**ECN/PCN No.: R0494**
**For Manufacturer**

| <b>Product Description:</b><br>Ceramic Chip Antenna 1575MHz | <b>Abracon Part Number / Part Series:</b><br>ACAG0301-1575-T | <input type="checkbox"/> Documentation only | <input type="checkbox"/> Series      |
| <b>Affected Revision:</b><br>A                              | <b>New Revision:</b><br>B                                    | <input checked="" type="checkbox"/> ECN     | <input type="checkbox"/> Part Number |

## Engineering/Process Change Notice

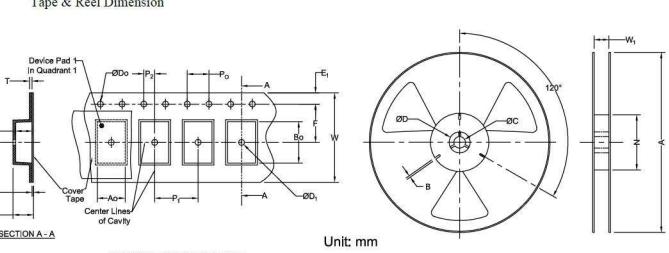
**Cause/Reason for Change:**

Updated packaging information

**Packaging**

Reel (3000 pcs/Reel)  
Size of the carton: 404 x 206 x 250 mm  
Tape & Reel Dimension

**Carrier Tape Specifications (mm)**

| Do         | Ko        | E1         | P0        | P1         | T           | F          | P1        | W          | Ao        | Bo        | Reel Qty |
| 1.50 ± 0.1 | 1.3 ± 0.1 | 1.75 ± 0.1 | 4.0 ± 0.1 | 2.0 ± 0.10 | 0.22 ± 0.05 | 3.5 ± 0.10 | 4.0 ± 0.1 | 8.0 ± 0.10 | 2.0 ± 0.1 | 3.5 ± 0.1 | 3,000    |

**Reel Specifications (mm)**

| A         | W1        | N  | C        |
| 178 ± 2.0 | 8.5 ± 1.0 | 60 | 13 ± 0.5 |
